BULLETIN # 20

PROJECT: Harrison Recreation & Community Center – PHASE 2
Harrison, NY

RE: Stair A Storage Closet

Sheet Title
STAIR A STORAGE CLOSET

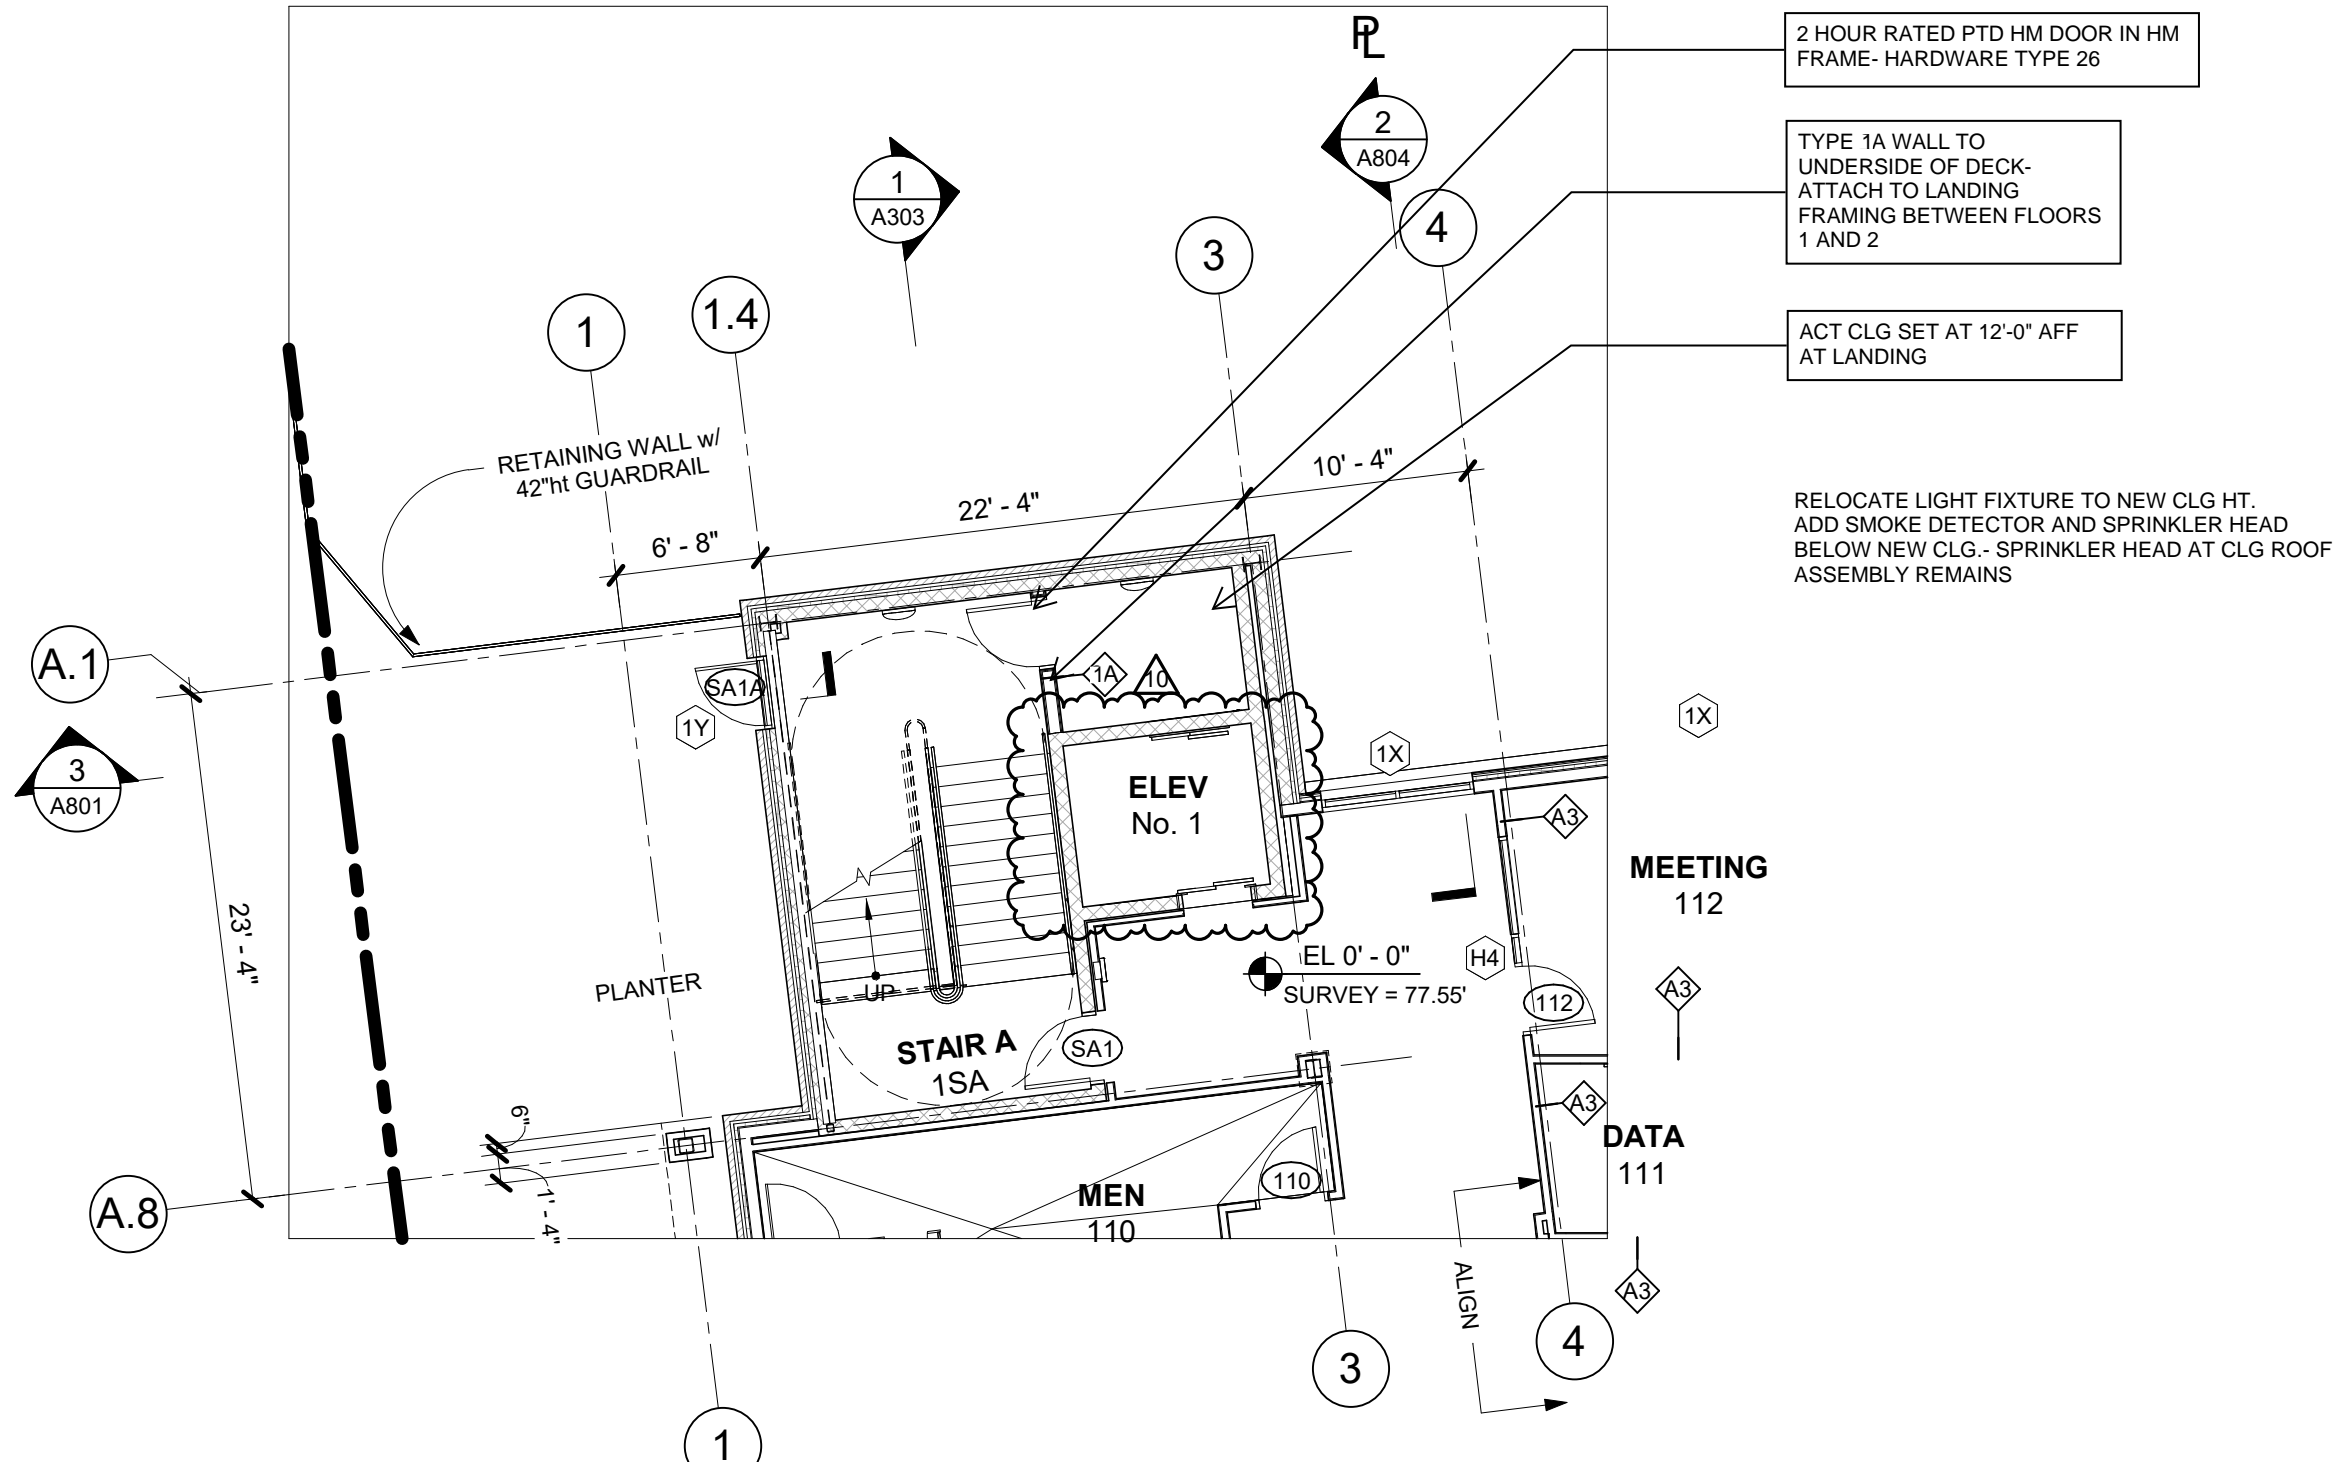
Please provide pricing for the additional Storage Closet shown on the attached ASK-23. Scope to include additional smoke detector, dry type sprinkler head, 1 hour rated GWB wall and HM door and frame with hardware type 26.

2 HOUR RATED PTD HM DOOR IN HM FRAME- HARDWARE TYPE 26

TYPE 1A WALL TO UNDERSIDE OF DECK- ATTACH TO LANDING FRAMING BETWEEN FLOORS 1 AND 2

ACT CLG SET AT 12'-0" AFF AT LANDING

RELOCATE LIGHT FIXTURE TO NEW CLG HT. ADD SMOKE DETECTOR AND SPRINKLER HEAD BELOW NEW CLG.- SPRINKLER HEAD AT CLG ROOF ASSEMBLY REMAINS
